## DEVELOPMENT MANAGEMENT COMMITTEE

### ADDENDUM SHEET

**20/02519/MFA Construction of 58 apartments, external amenity spaces and communal garden/play area.**

**20/01754/MFA      Construction of 28 residential dwellings (including 50% affordable housing) with access off Tring Road, including parking and garaging, creation of public open space, landscaping, and all enabling and ancillary works.**

The accompanying site plan and photographs of 5 Cinders Close Needingworth St Ives PE27 4TZ show a roadway similar to The Oaks Berkhamsted.

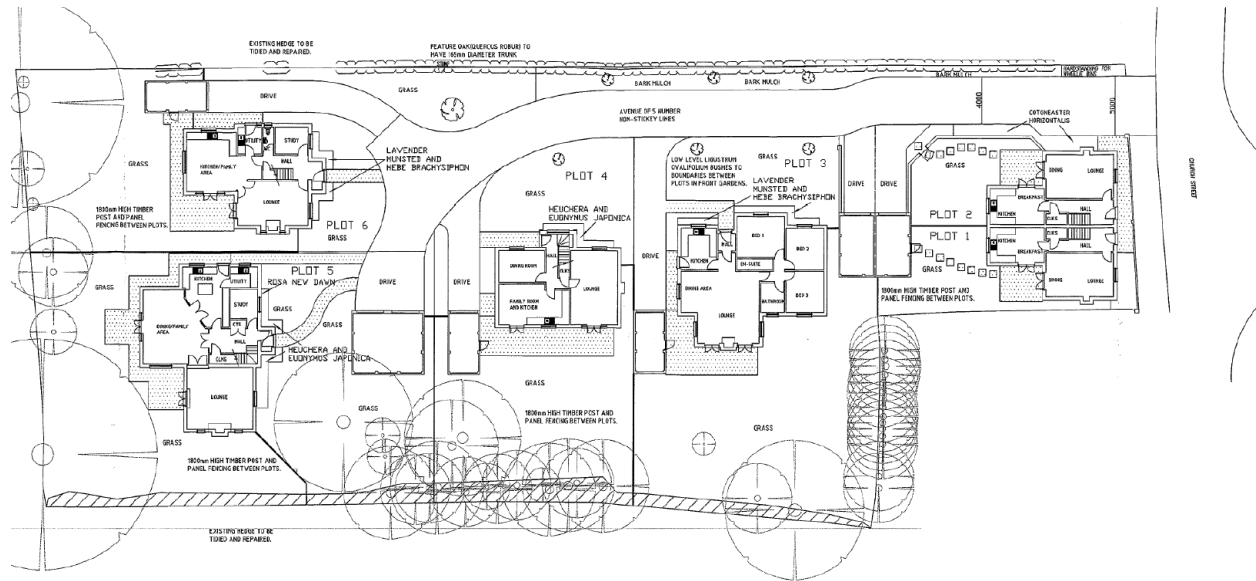
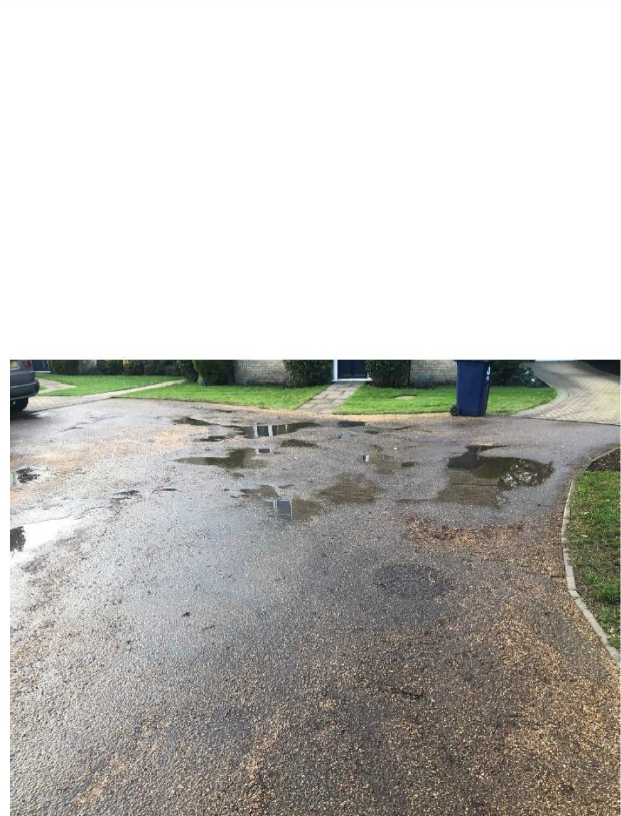
The below ground conditions here are perfect for construction solid gravel with fine sandy soil but despite this there are cracks and puddling through and the surface bonding is a constant maintenance headache for the owners.

It was last repaired a few years ago but no one in the cul-de-sac wants to pay for it to be further repaired as they have been advised that the whole top layer needs to be taken off and then re-laid!!

Clearstone resin bound surfacing specification sheet

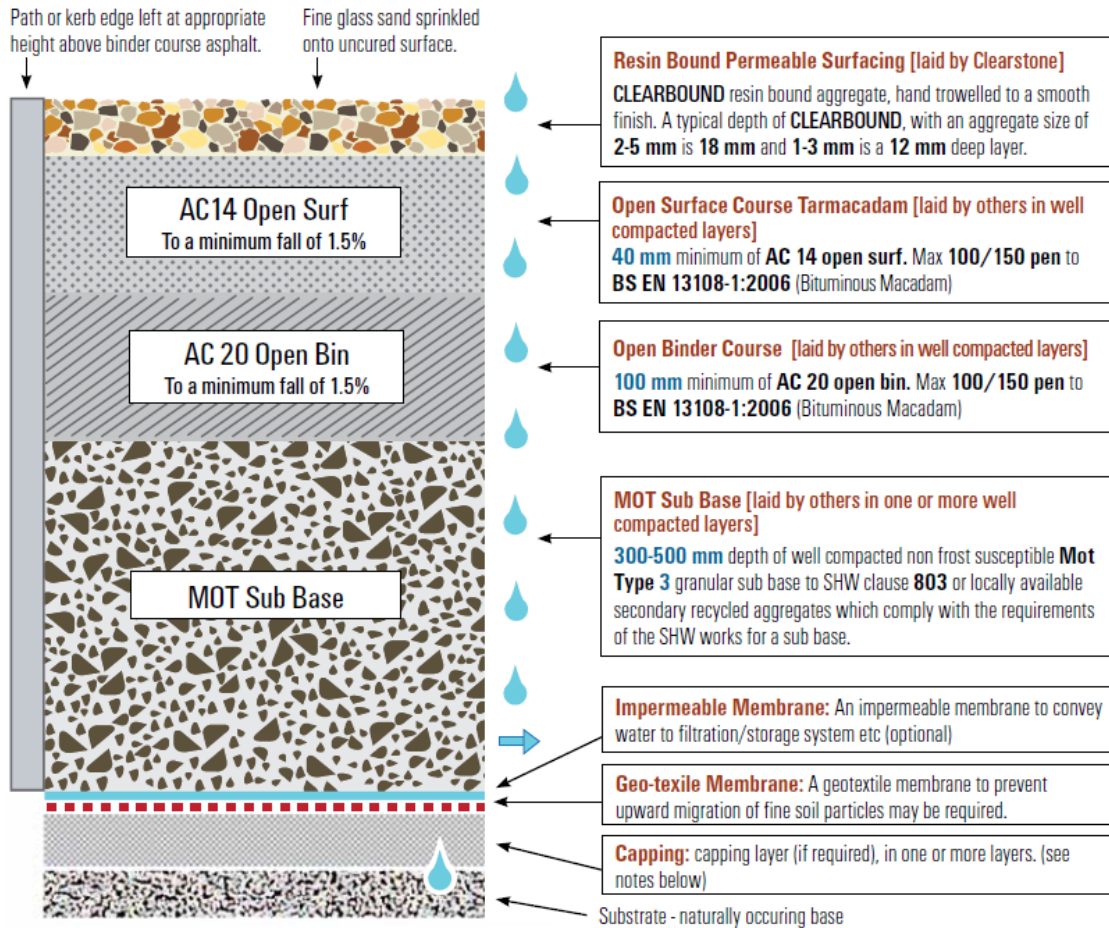
**Planning Permission SuDS:** Resin bound surfacing creates an attractive, permeable and durable surface which avoids the need for planning permission under the 2008 SuDS Planning Order 1998 on the paving of front gardens. **Notes:**
